ISSUES & REVISIONS		DATE:
FOR PERMIT		AUGUST 9, 2023
FOR CONSTRUCTION		MARCH 25, 2024
CONSTRUCTION BULLETIN #1		MAY 15, 2024
CONSTRUCTION BULLETIN #2		NOVEMBER 15, 2024
LIGHTING SPECIFICATIONS REQUEST		FEBRUARY 13, 2025
CONSTRUCTION BULLETIN #3		FEBRUARY 20, 2025
OWNER APPROVED PLANS		FEBRUARY 28, 2025

PROJECT TITLE:	
LOPA COMPOUND DEVELOPMENT	
Lopa Farm Marilaque Highway Sitio Mayagay, Brgy. Sampaloc, Tanay Rizal

SHEET CONTENTS:	
HOUSE 5 FLOOR PLAN AND ROOF PLAN

1
A-100
1/F FLOOR PLAN
SCALE:1:50

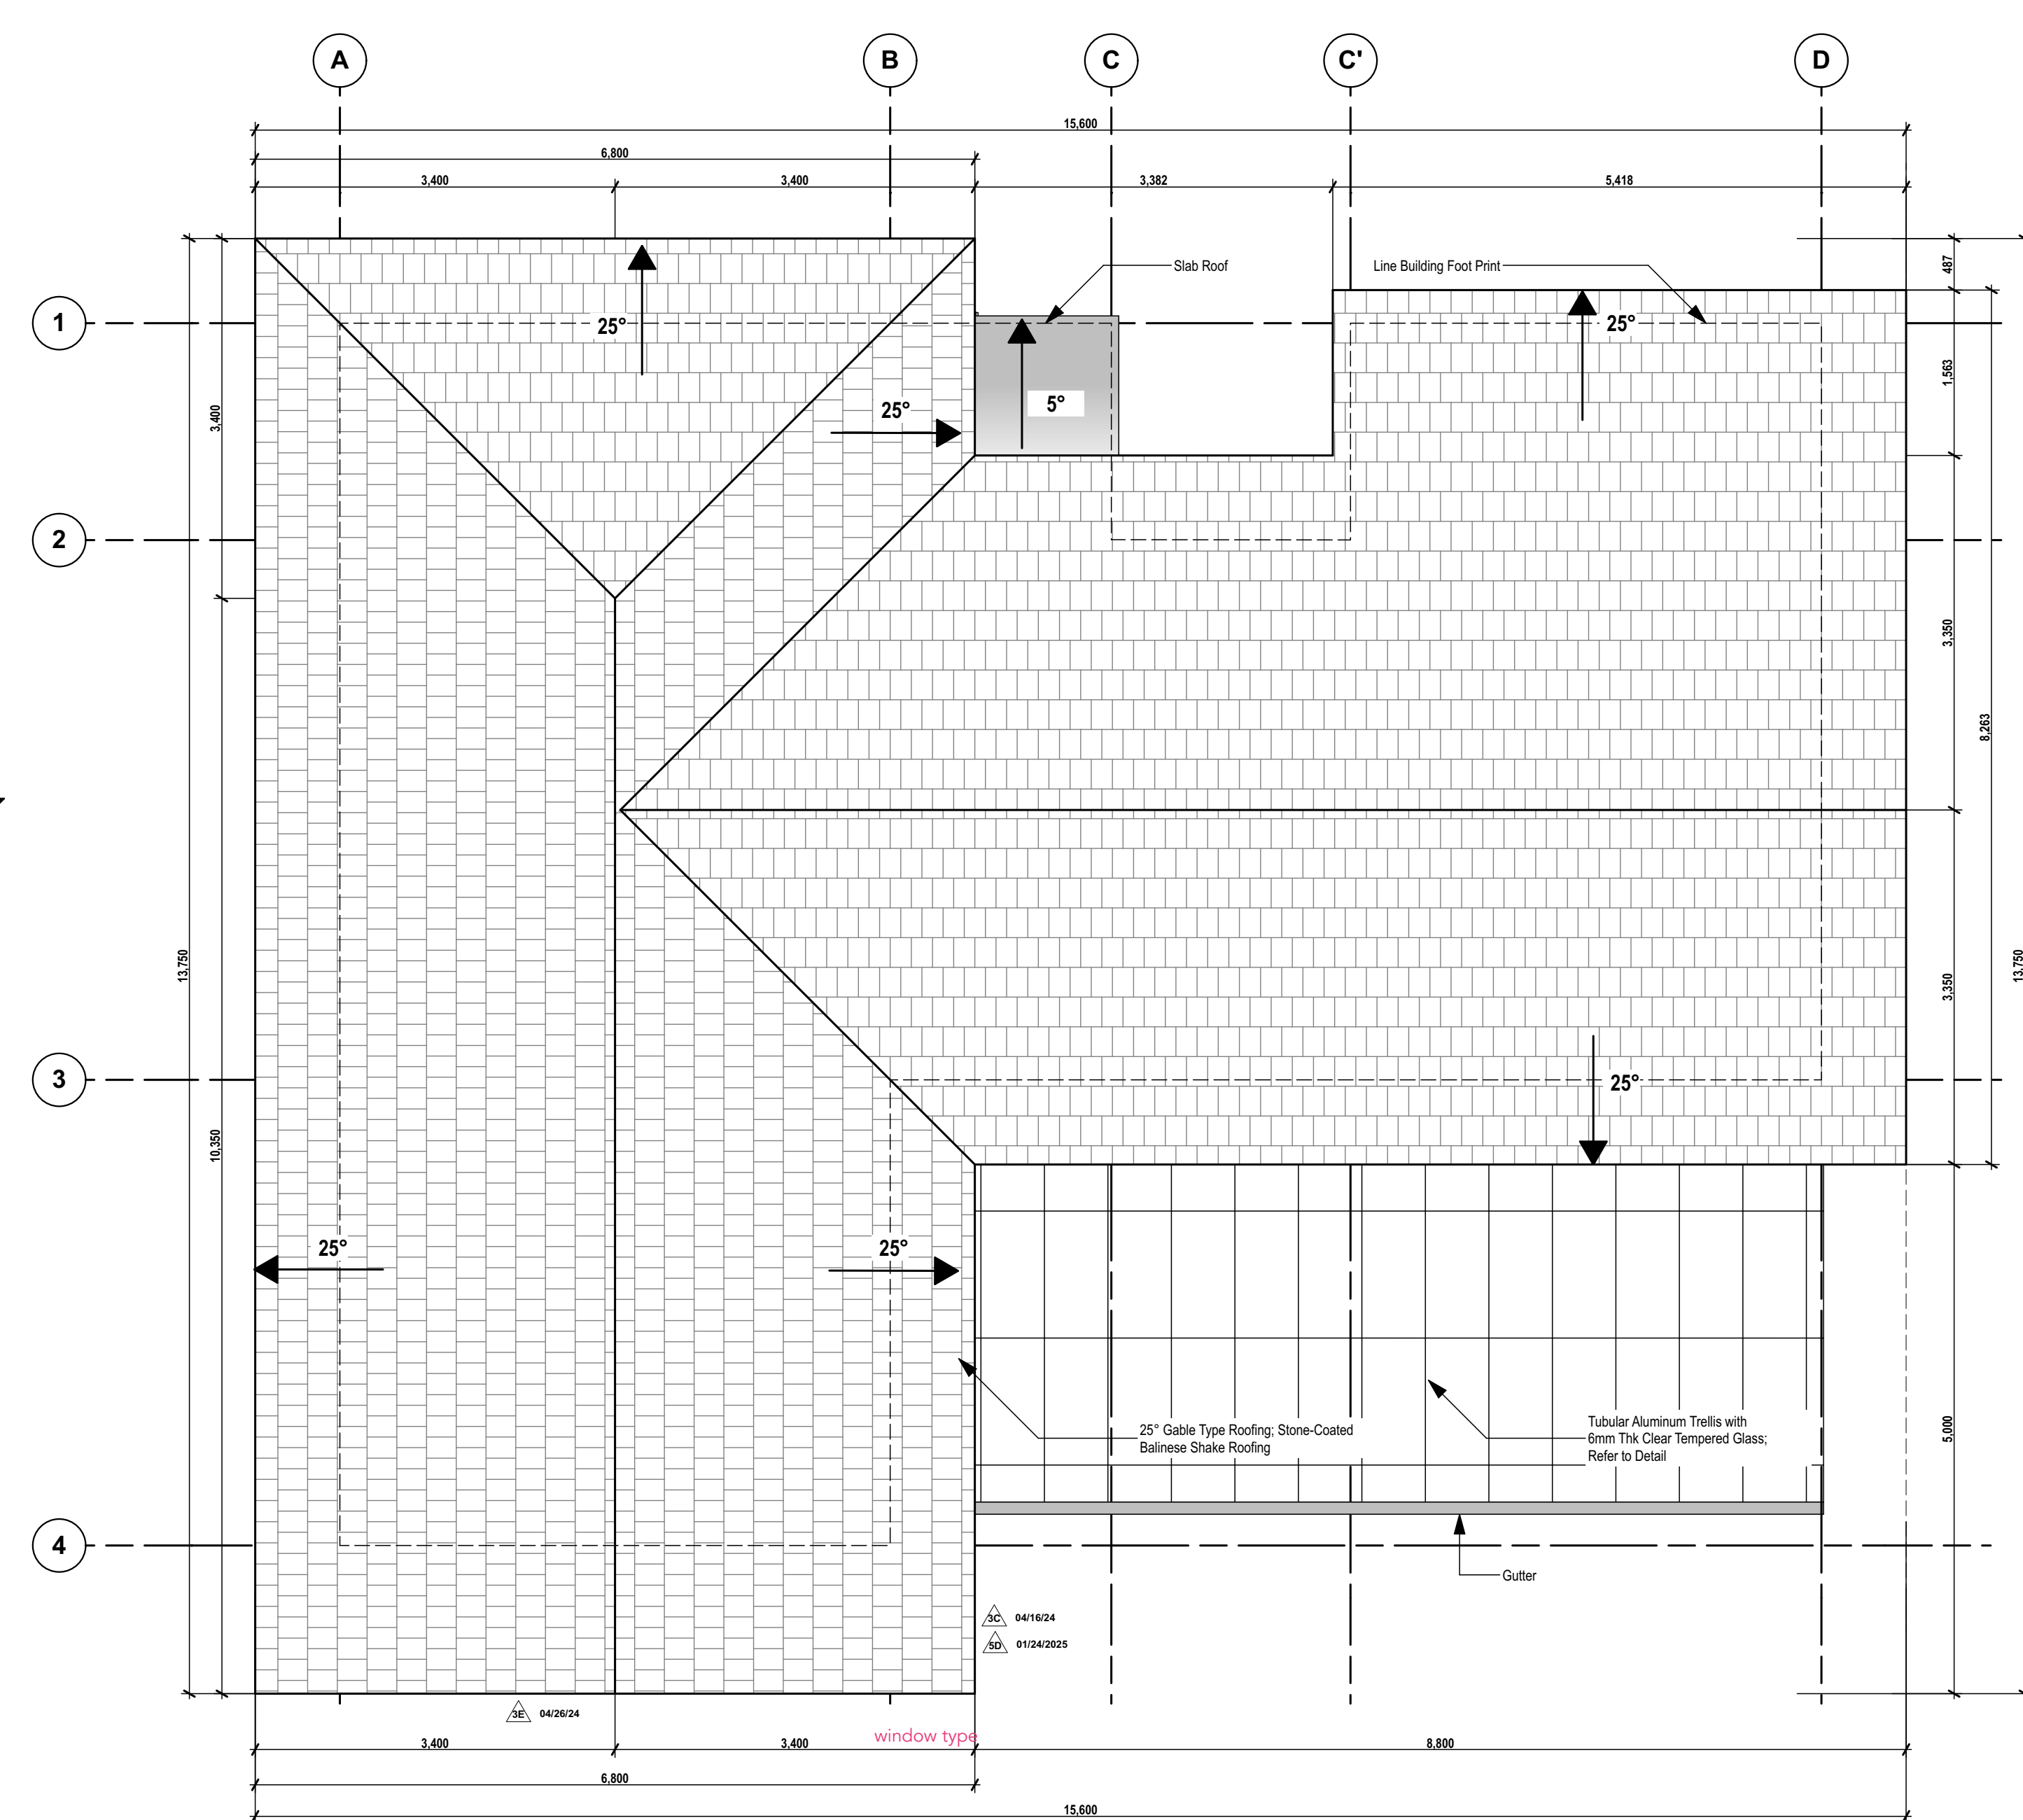
REVISION NOTES	
NOVEMBER 15, 2024	4A - REFLECTED FLOOR ELEVATION/DEPRESSION ON FLOOR FINISH PLAN
	4B - VERIFIED ELEVATIONS
01/24/2025	5A - ADDITION OF CABINET AT BEDROOM
	5B - CHANGED THE MATERIAL OF THE DOOR FROM ALUMINUM TO SOLID WOOD
	5C - LAVATORY HAS BEEN REPLACED FROM DOUBLE TO SINGULAR LAVATORY; TOILET HAS BEEN ADJUSTED TO GIVE WAY FOR CABINET. CABINET HAS BEEN ADDED
	5D - ADDITION OF GUTTER AT GLASS TRELLIS
	5E - ADDITION OF SLOP SINK
02/28/2025	6A - ADDITION OF DOUBLE WALL AT BASEMENT TOILET FOR PIPING

SCALE:	AS SHOWN	SHEET NO : A-101
DRAWN BY:	ADI, JJC, NEC, MMT, BCA	
CHECKED BY:	MCD	
DATE:	02/20/2025	
REVISED:

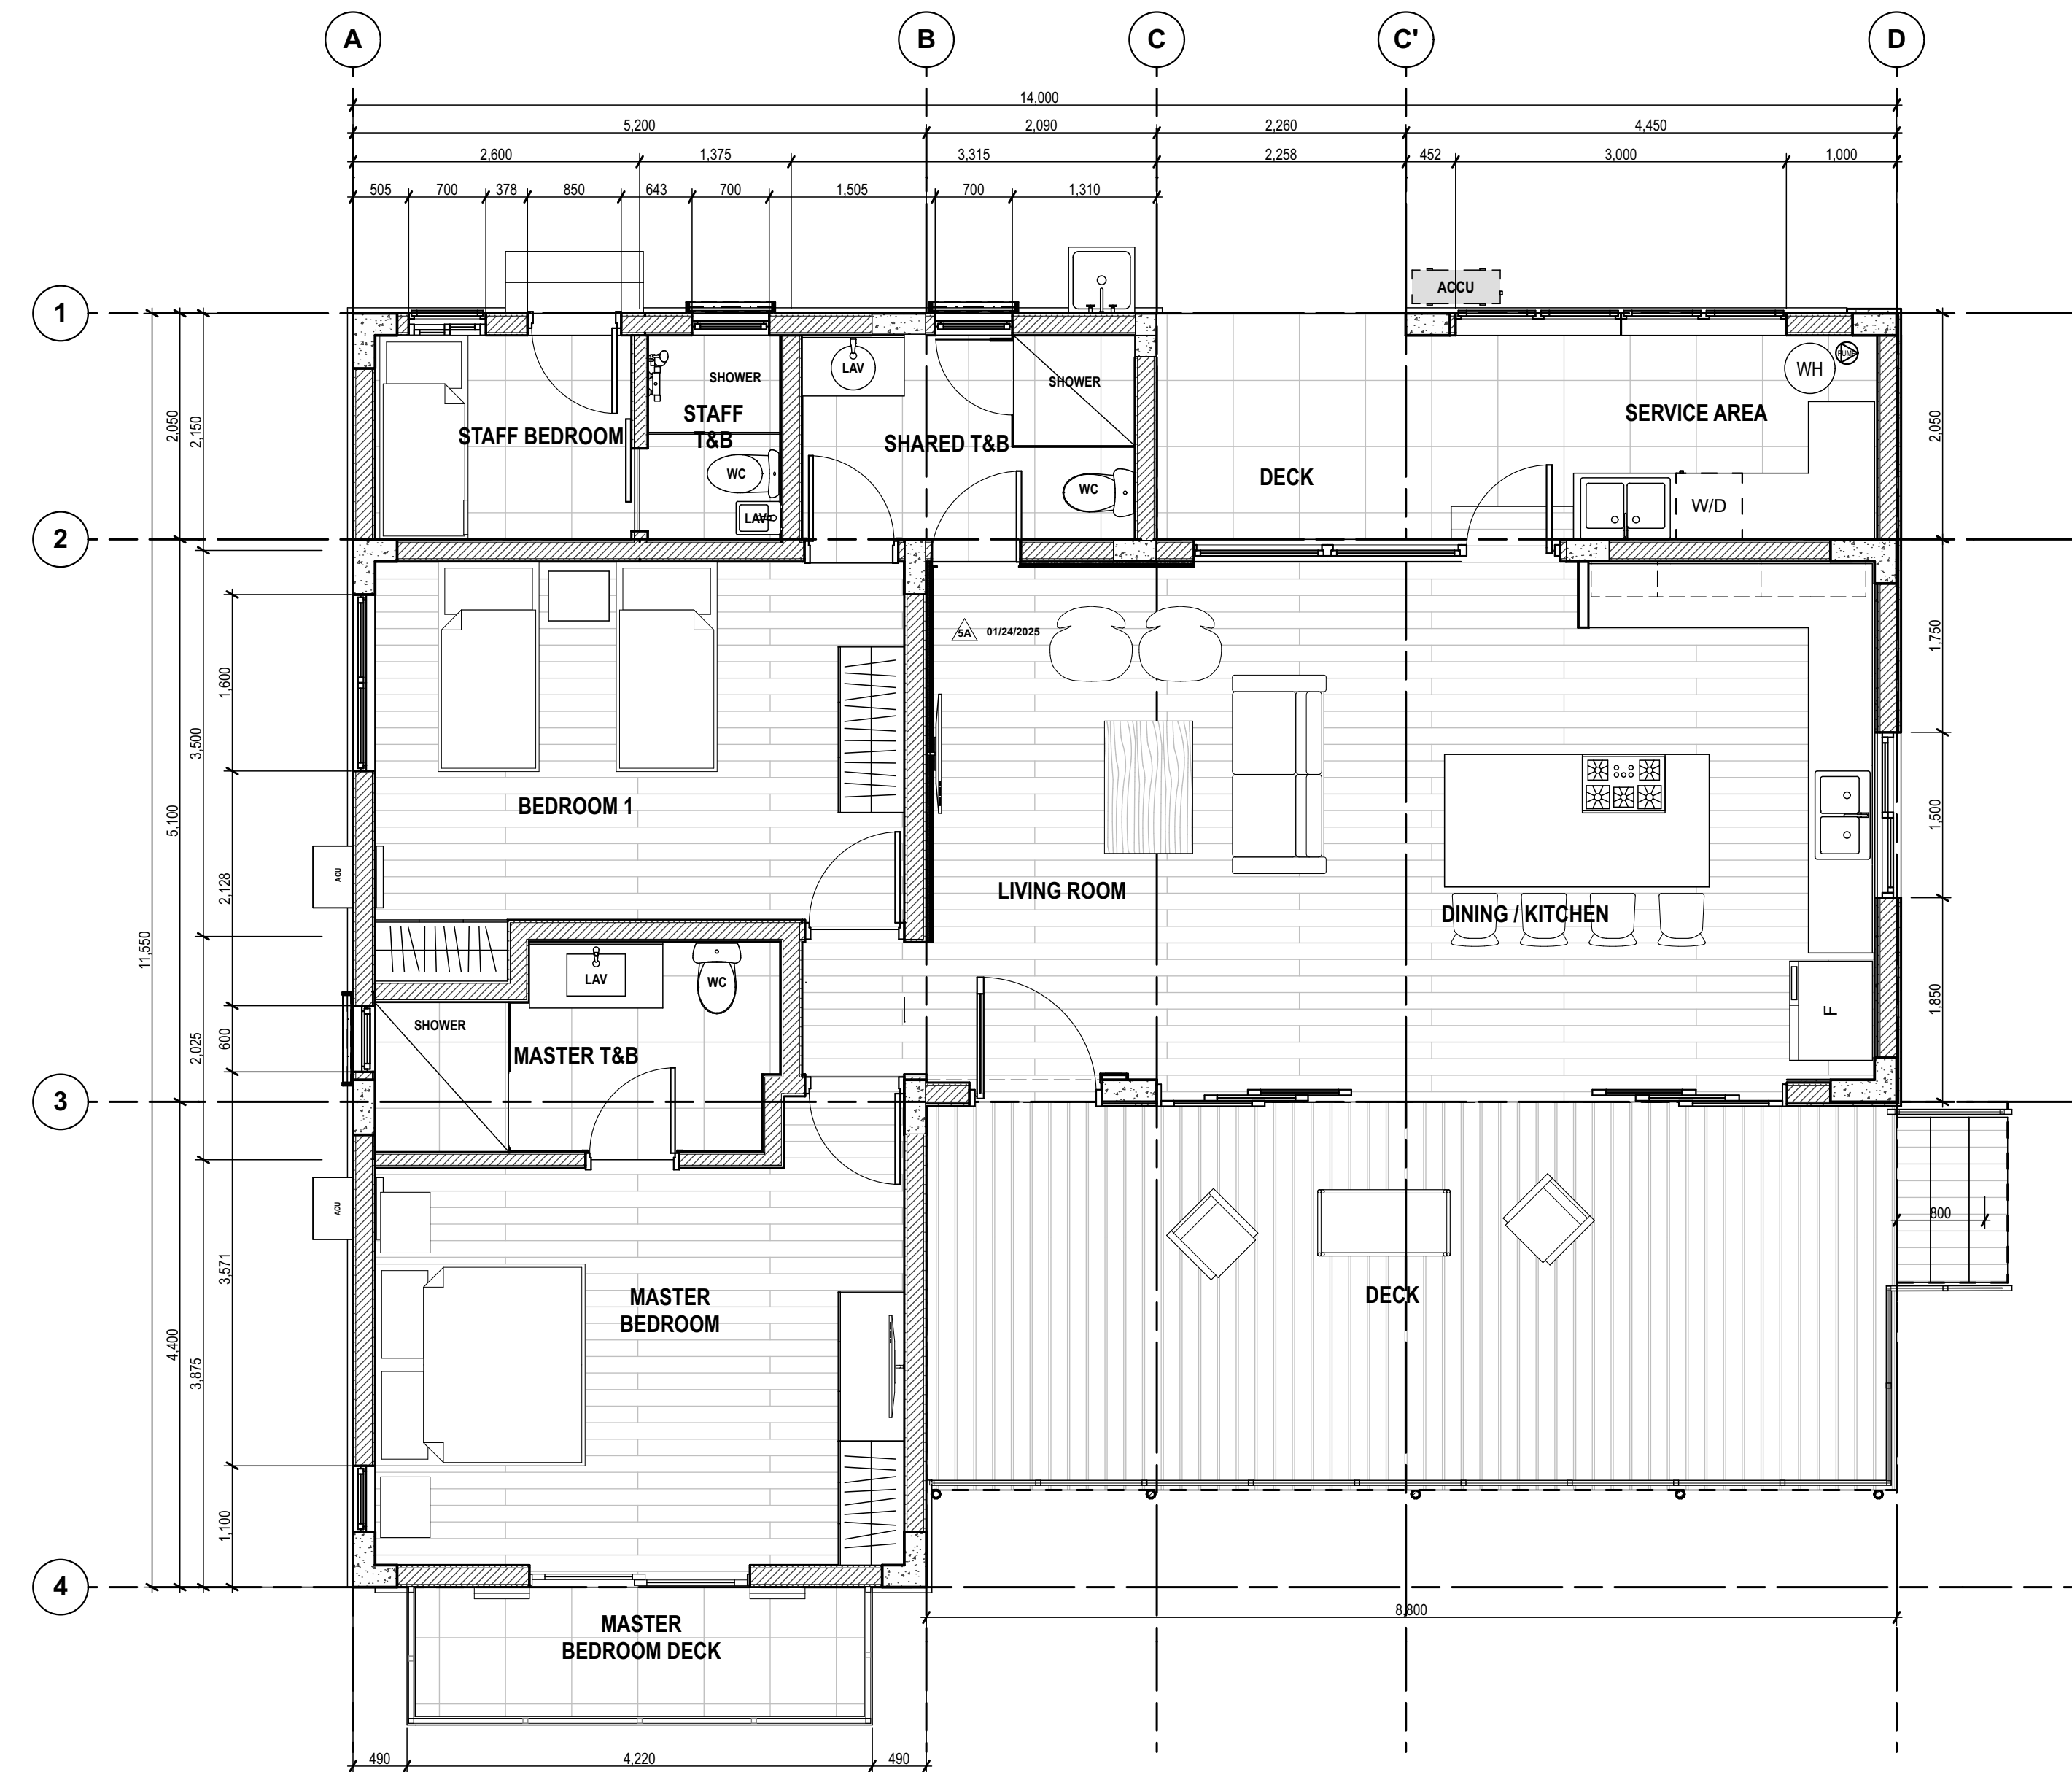
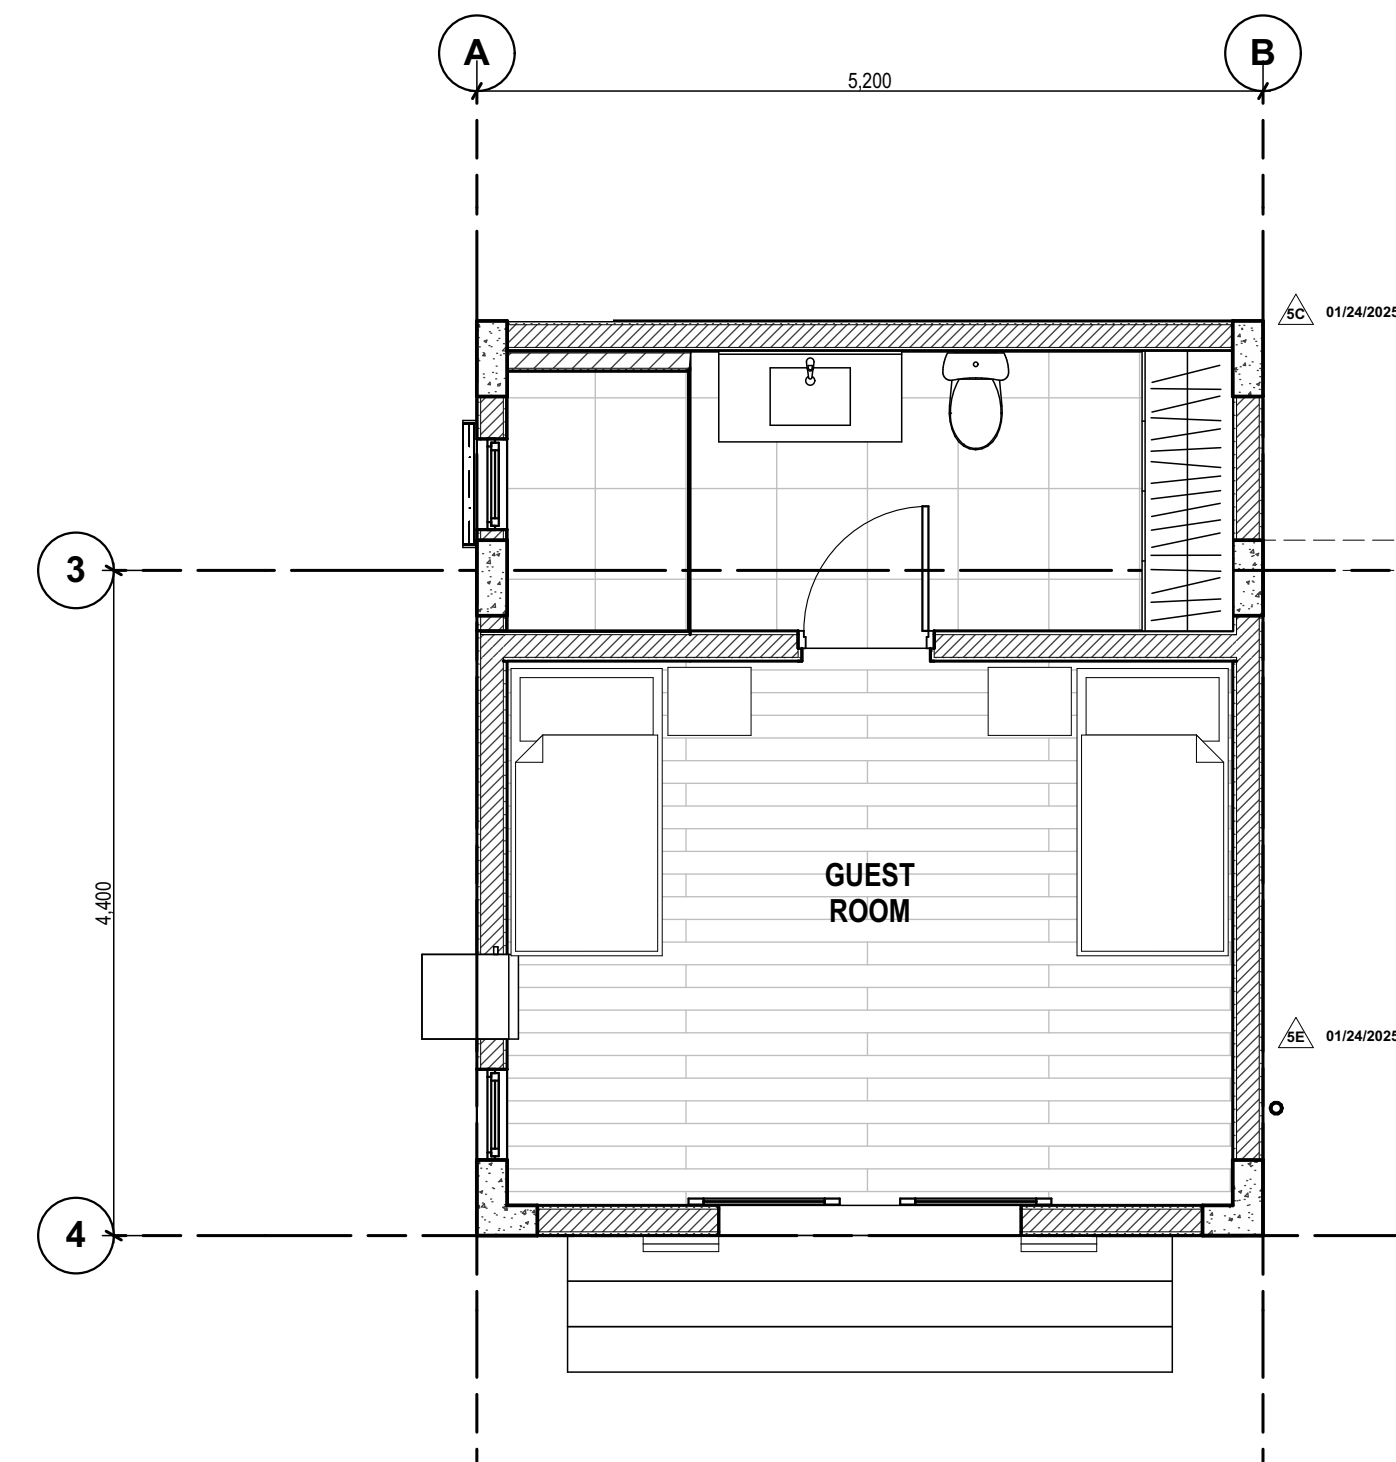
REVISION NOTES	
NOVEMBER 15, 2024	4A - REFLECTED FLOOR ELEVATION/DEPRESSION ON FLOOR FINISH PLAN
	4B - VERIFIED ELEVATIONS
JANUARY 24, 2025	5A - ADDITION OF CABINET AT BEDROOM
	5B - CHANGED THE MATERIAL OF THE DOOR FROM ALUMINUM TO SOLID WOOD
	5C - LAVATORY HAS BEEN REPLACED FROM DOUBLE TO SINGULAR LAVATORY; TOILET HAS BEEN ADJUSTED TO GIVE WAY FOR CABINET. CABINET HAS BEEN ADDED
	5E - PROPOSED BED LAYOUT AND LOCATION FOR MURPHY BED PROVISION
